V2500 Propulsion System — Nacelle

Subject: Transmittal of Revision 2 to Service Bulletin Number V2500-NAC-71-0231

NACELLE — POWERPLANT — UPPER FITTING, THRUST REVERSER OPENING ACTUATOR  
- REPLACEMENT OF

V2500-NAC-71-0231  
Page 1 of 10

Thrust Reverser Opening Actuator Upper Fitting Assembly Replacement  
Figure 1

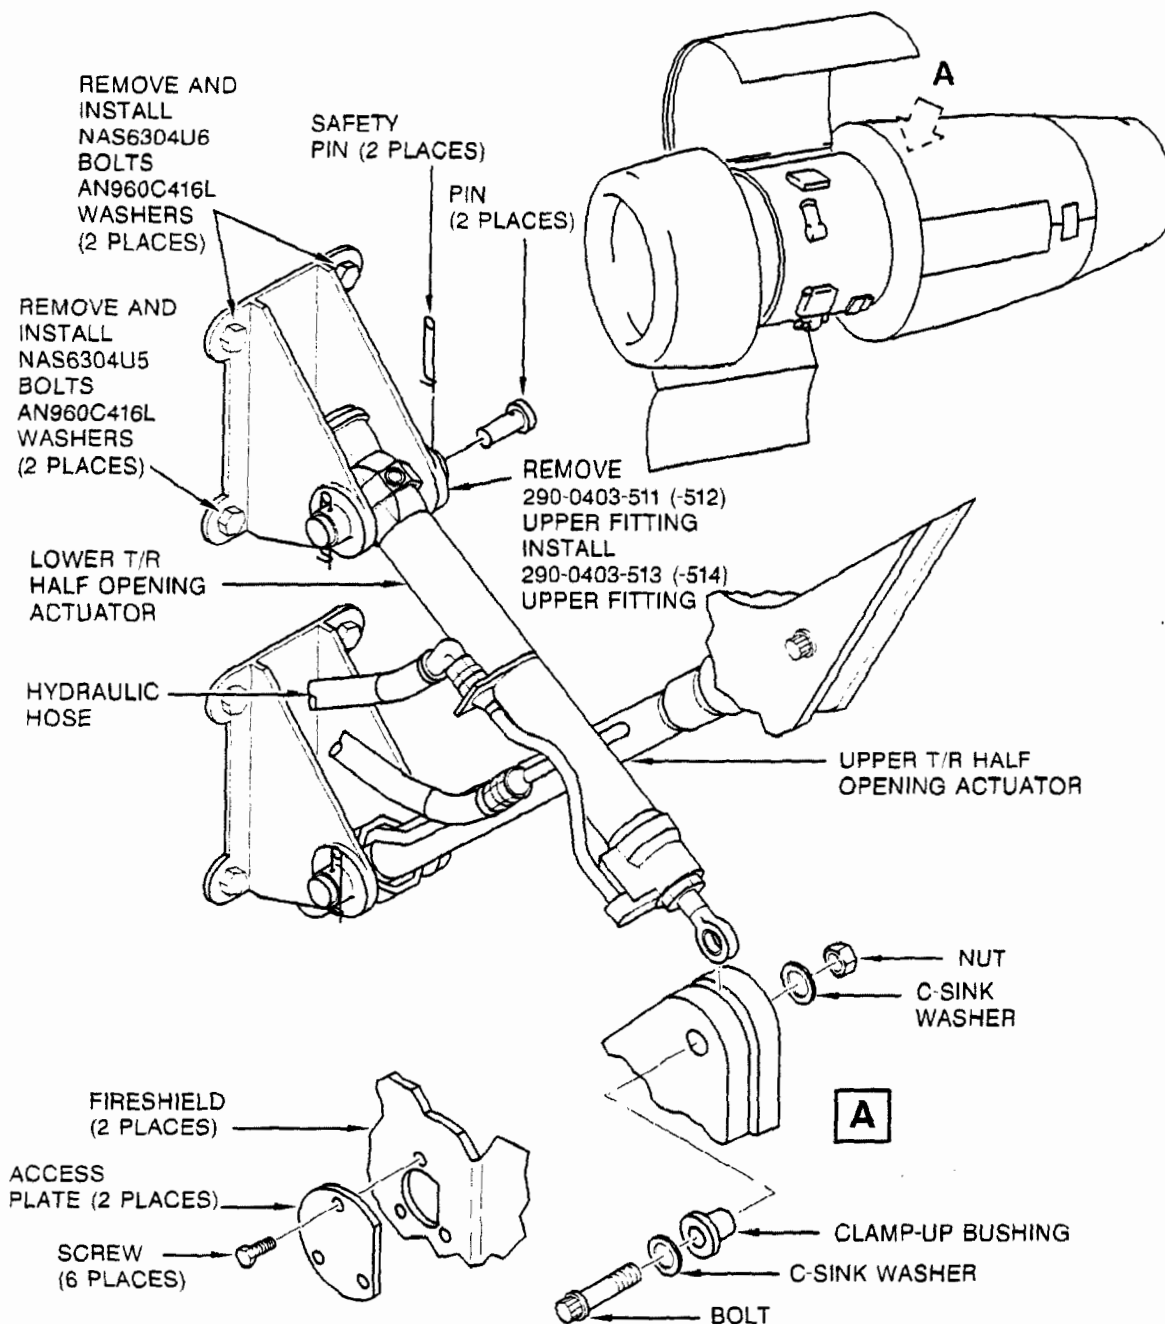
The pylon mounted upper fitting for the thrust reverser lower half opening actuator can become wider in service. This can allow the actuator pivot pins to disengage and result in the lower thrust reverser half swinging free when the thrust reverser is opened.

The configuration of the upper fitting does not allow the actuator to move freely through the full range of motion. The gimbal of the actuator interferes with the support bracket and causes it to become wider.

Replaces the pylon mounted upper fitting with an improved configuration.

- (1) Remove the NAS6304U6 bolts, NAS6304U5 bolts, AN960C416L washers, and 290-0403-511 (-512) upper fitting from the pylon. Refer to Figure 1.
- (2) Install the 290-0403-513 (-514) upper fitting on the pylon with the AN960C416L washers, NAS6304U5 bolts, and NAS6304U6 bolts. Torque the bolts to 63-70 inlbs (7-8 Nm).
